## Basecamp Phase 2 Apartments – Drainage Letter

### Drainage Letter

Basecamp Phase 2 Apartments, Steamboat Springs, Colorado

**Figure 1- Vicinity Map**

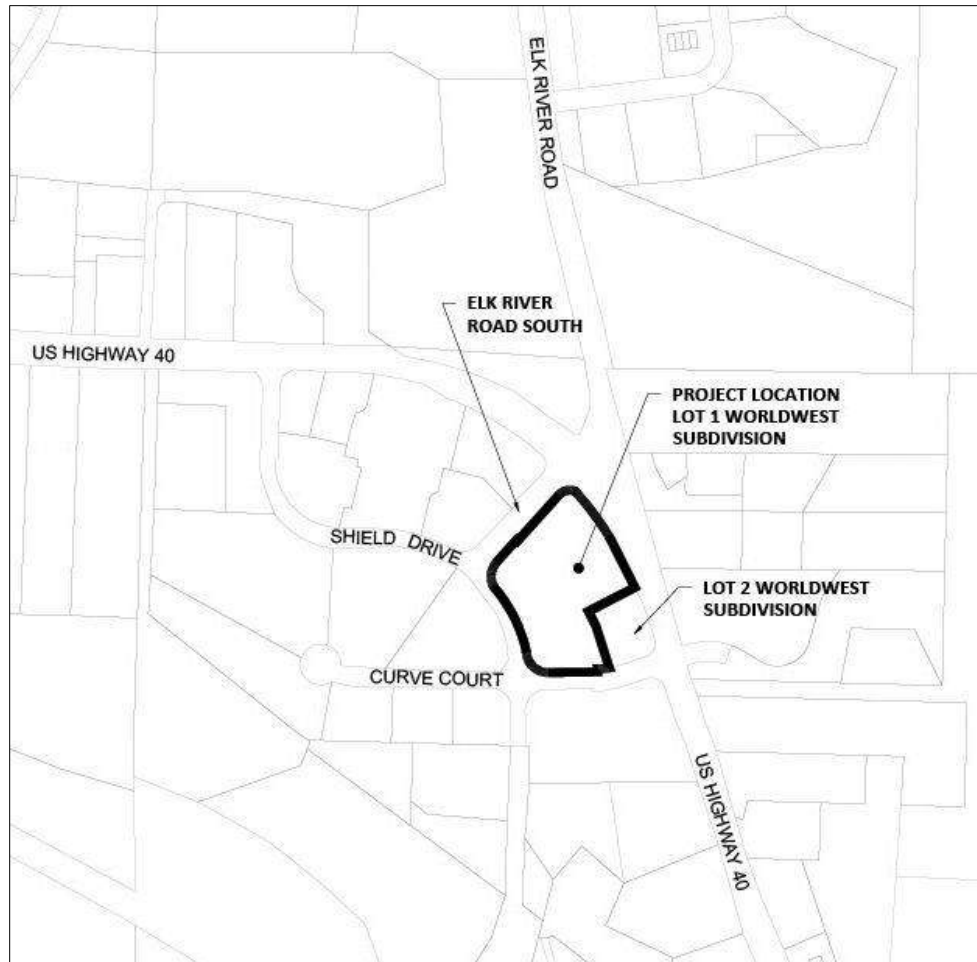
(Drainage Letter): Please show all calculations for all subbasins.
